**Economic and Social Council**Distr.: General
22 December 2011

Economic Commission for Europe**Inland Transport Committee****World Forum for Harmonization of Vehicle Regulations****156th session**

**1958 Agreement – Consideration of draft amendments
to existing Regulations submitted by GRE****Proposal for the 06 series of amendments to Regulation
No. 48 (Installation of lighting and light-signalling devices)****Submitted by the Working Party on Lighting and Light-
Signalling ***

Model A

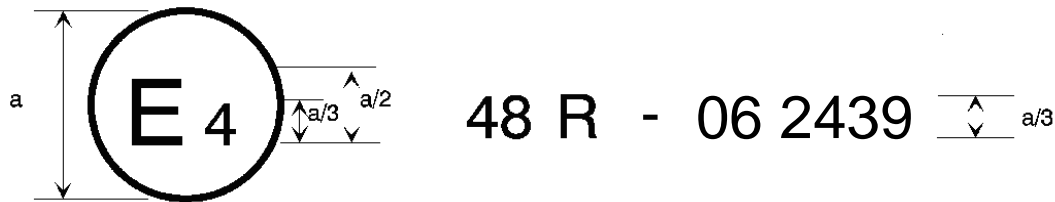
Annex 2, amend to read:

The above ... Regulation No. 48 as amended by the 06 series of amendments. The approval number indicates that the approval was granted in accordance with the requirements of Regulation No. 48 as amended by the 06 series of amendments.

Model B

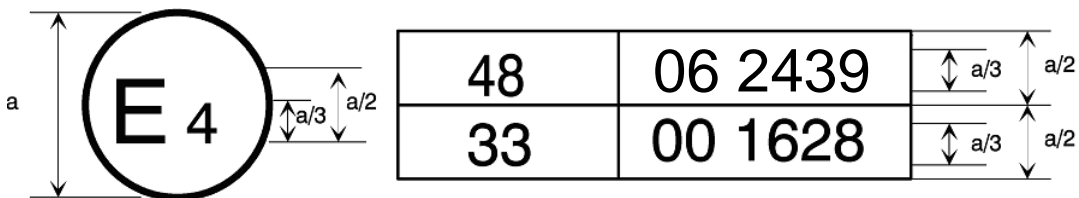
The above ... Regulation No. 48 as amended by the 06 series of amendments and Regulation No. 33.^{1/} The approval number indicates that, at the dates

when the respective approvals were given, Regulation No. 48 was amended by the 06 series of amendments and Regulation No. 33 was still in its original form."
